**RE: EQUINIX (IRELAND) LTD.,
PLOT 100, PROFILE PARK, NANGOR ROAD, CLONDALKIN, DUBLIN 22,**

Please find our response to Item No. 7, addressing the Request For Additional Information pertaining to the above project, as dated 22nd July 2022, together with 6 No. copies of all documentation, as mentioned below:-

**RE: EQUINIX (IRELAND) LTD.,
PLOT 100, PROFILE PARK, NANGOR ROAD, CLONDALKIN, DUBLIN 22,
PLANNING REG. REF. SD21A/0186**

Please find our response to Item No. 1(a) & (b-part), addressing the Request for Clarification of Additional Information pertaining to the above project, as dated 17th January 2022, together with 6 No. copies of all documentation, as listed below. Note that Items 1(c) & (d) are to be responded to by others:-

(b)(ii): Refer Drawing No: DB080-PIN-00-ZZ-DR-C-PLAN-1207 Rev. P03 (extract below), which indicates the overall site reticulation network and the connections of the pipe network draining into the respective attenuation storage features.

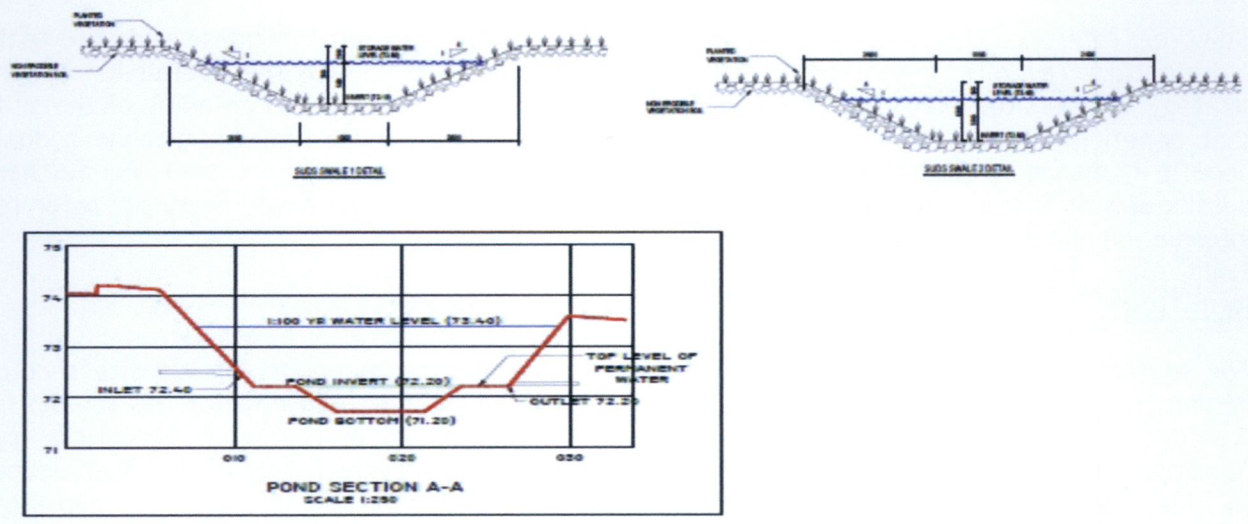
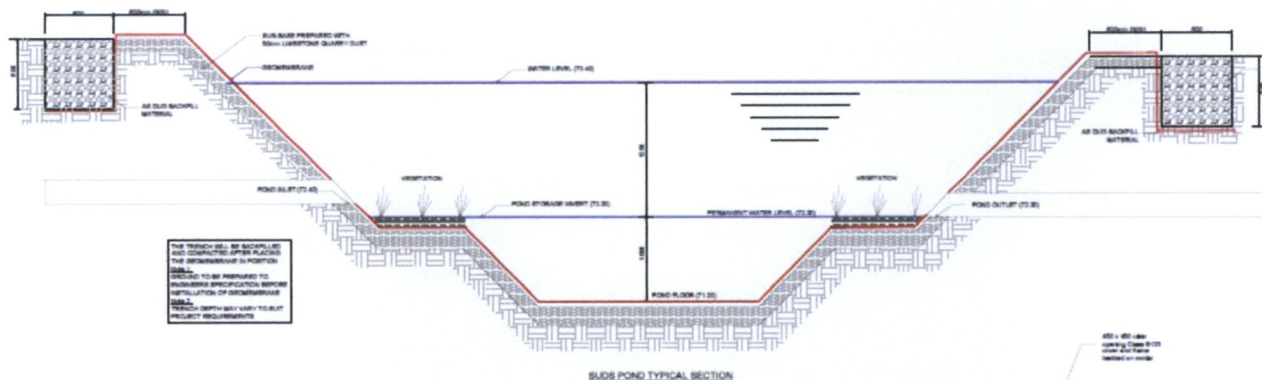
(ii) The applicant is required to submit Engineering drawings showing the inclusion of more SuDS for the development as outlined in Item b) i. The drawing should show how the SuDS features are incorporated with the surface water drainage network on the site. A cross sectional detail is required of all proposed SuDS features.

Cross sections of the attenuation pond and swales (extracts below), have been incorporated on Drawing No's: DB080-PIN-00-ZZ-DR-C-PLAN-1295 Rev. P03 & 1296 Rev. P03.
